Introduction Some customers may notice a creaking noise coming from the inner door handles when opening the front driver and passenger doors. The door handle assembly has been improved to correct this condition.

Applicable • 2007 model year FJ Cruiser vehicles produced BEFORE the Production Change Effective VINs shown below.

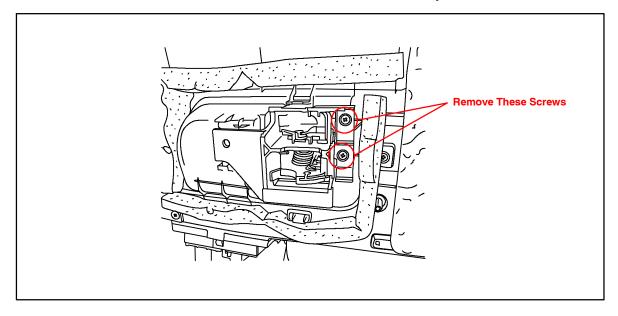
- **Repair** 1. Remove the front door panel. **Procedure**
 - Refer to the Technical Information System (TIS), 2007 model year FJ Cruiser Repair Manual, Vehicle Exterior - Door/Hatch - "Engine Hood/Door: Front Door: Disassembly".
 - 2. Remove the two screws and the inside door handle assembly.

3. Install the NEW inside door handle assembly in reverse order and reassemble the door panel.

NOTE:

Be sure to securely fasten the front door lock remote control cable and front door inside locking cable to the handle assembly before reassembly, as shown below.
